Access Compliance Report

Public Rights-of-Way (Curb Ramps)

Intersection ID: 22358	Main Street: HINSON_DR	Cross Street: TADLOCK_PL	Location: NW
ADA ID: 3DCC67136735	Ramp Type: Directional1	Initial Pass/Fail: Fail	Overall Compliance: No
		Severity Score: 25

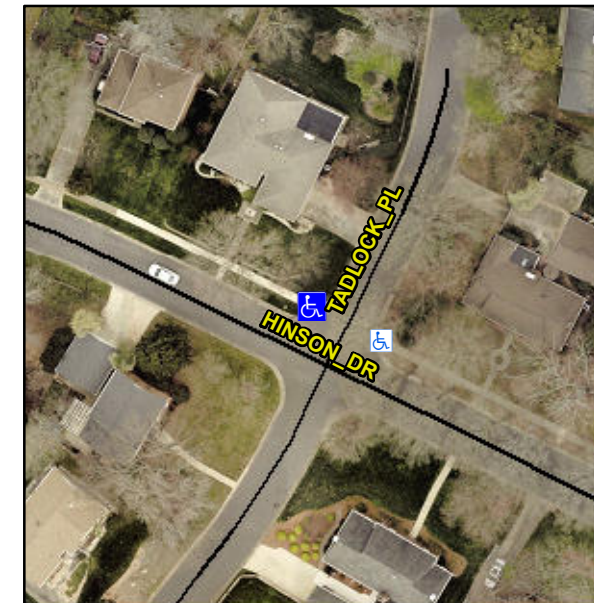
R304.5.3

Compliance	Description	Data	Compliance	Description	Data
N/A	Ramp Length (in)	74.0	N/A	Grade Break?	N/A
Yes	Ramp Width (in)	48.0	N/A	Grade Break Slope (%)	0.0
Yes	Ramp Slope (%)	2.4	N/A	Grade Break XSlope (%)	0.0
No	Ramp XSlope (%)	11.3			
N/A	Flare Type LT	N/A	N/A	Flare Type RT	N/A
N/A	Flare Slope LT (%)	N/A	N/A	Flare Slope RT (%)	0.0
N/A	Flare Traversable LT?	N/A	N/A	Flare Traversable RT?	N/A
N/A	Landing Length (in)	0.0	N/A	DWS Provided?	N/A
N/A	Landing Width (in)	0.0	N/A	DWS Contrast?	N/A
N/A	Landing Slope (%)	0.0	N/A	DWS Length (in)	N/A
N/A	Landing X Slope (%)	0.0	N/A	DWS Full Width?	N/A
N/A	Landing Curb? (Y/N)	N/A	N/A	DWS Offset LT (in)	N/A
N/A	Shared Landing?	N/A	N/A	DWS Offset RT (in)	N/A
N/A	Gutter Ponding?	0.0	N/A	Gutter Slope (%)	N/A
N/A	Gutter Lip Ht (in)	0.0	N/A	Gutter X Slope (%)	N/A
N/A	Painted X Walk1?	No		Road Slope (%)	6.1
	X Walk 1 Direction	To E		Road X Slope (%)	3.7
	X Walk 1 Width (in)	N/A		Clear Space?	N/A

Remove & Replace Entire Ramp.
